## Determination 2010/10

# The refusal of a building consent for proposed house alterations and additions at 17 Winsomere Crescent, Westmere, Auckland

Figure 1: Section through deck and roof

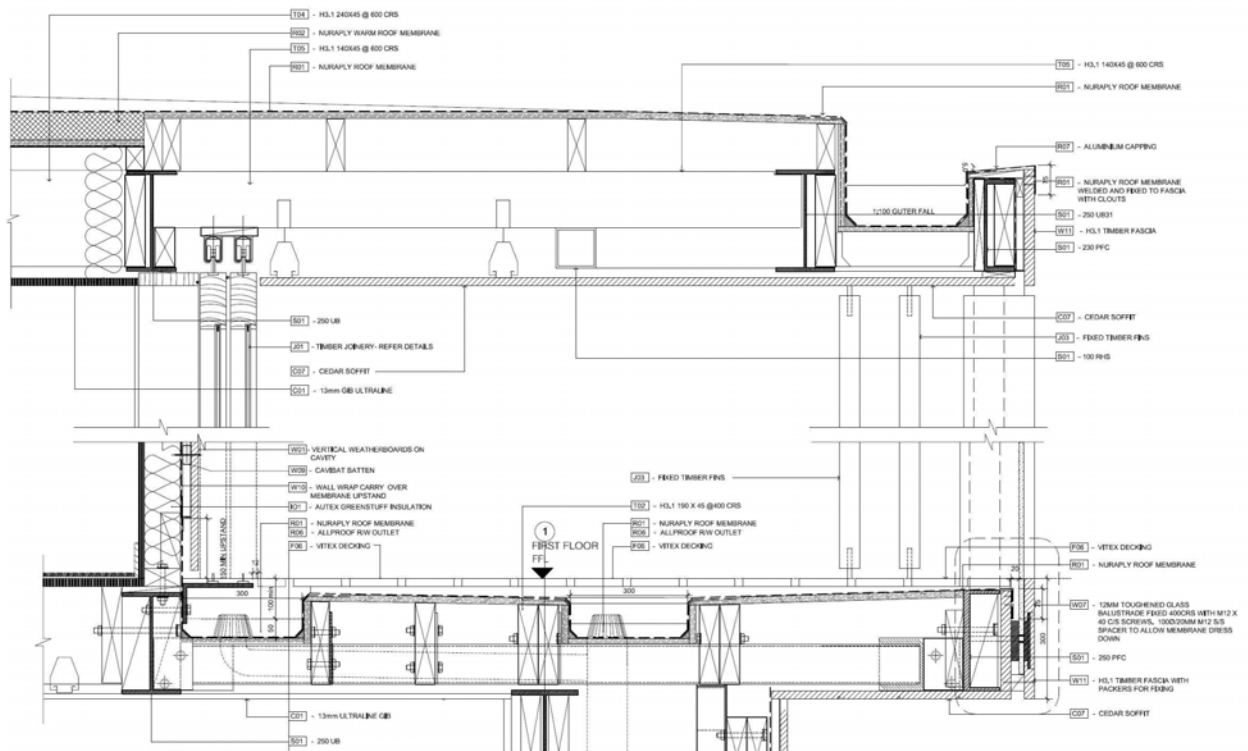
- The deck is fully covered by the roof overhang and the amount of rainfall reaching the deck membrane area will be limited. The deck membrane surface, including the joints and gutters, is protected from foot traffic by the removable decking.
- The deck is long and narrow with two deck gutters – one along the wall and the other outside the line of the lower wall, with the maximum cross fall towards the gutter limited to about 800mm.
- Ponding on the deck and gutter membranes is unlikely to occur, as the steel framing provides rigidity for the structure (refer paragraph 3.8).

- The cross-section of the 300mm wide deck gutters significantly exceed the minimum given in the Acceptable Solution E1/AS1 for the deck areas drained.

- The roof gutters are supported by steel framing, resulting in a relatively rigid structure unlikely to result in ponding on the gutters (refer paragraph 3.8).
- The cross-section of the 300mm wide internal gutters is approximately five times greater than the minimum given in E1/AS1 for the maximum plan area of roof discharging into the gutter.
- At the parapet walls, the height of the outer edge of the gutters is about 100mm below the inner edge, which allows water to flow over the parapet top in the unlikely event that drainage capacity is exceeded during severe storms.

6.6 I acknowledge and accept that the authority has concerns with respect to the performance of low-pitched membrane roofs to buildings where deflection of the structure may give rise to ponding. However, the new upper level to the house is a specifically-designed steel structure that is considerably more resistant to deflection than conventional timber framing.

6.5 Taking into account the above observations, I consider that the membrane system proposed for the deck and gutters to this house is likely to perform at least as well as the materials and systems included within E2/AS1. I am therefore satisfied that the proposed gutters and deck for this house will meet the performance requirements of Clause E2 for the deck and roof to shed water.

- 7.1 In accordance with section 188 of the Building Act 2004, I hereby determine that the roof gutters and deck proposed for this building comply with Clauses B2 and E2 of the Building Code, and accordingly I reverse the authority's decision to refuse to grant the building consent, in respect only of the proposed falls to the deck membrane and gutters, and to the fall to the roof gutters.
